IN THE DRAWINGS

REMARKS

BLAKELY, SOKOLOFF, TAYLOR & ZAFMAN LLP

Dated: December 27, 2005

FIG. 10D

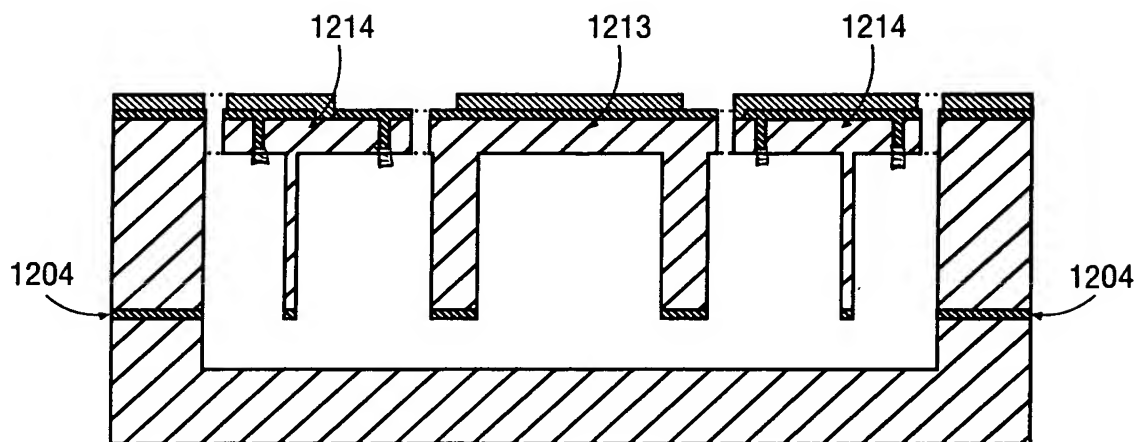
Annotated Sheets Showing Changes with respect to Figure 10D, 10E, and 12E of the drawings is provided with proposed change indicated in red ink. Corresponding Replacement Sheets are also enclosed. Applicants submit that the drawing as amended does not add new matter given that support is found in the originally filed drawings and in the specification at page 35, lines 1-5.

Figures 10D, 10E, and 12E have been amended to conform the formal drawings to the originally-filed drawings. Support for the corrections is found in originally filed Figures 10D, 10E, and 12E of the drawings.
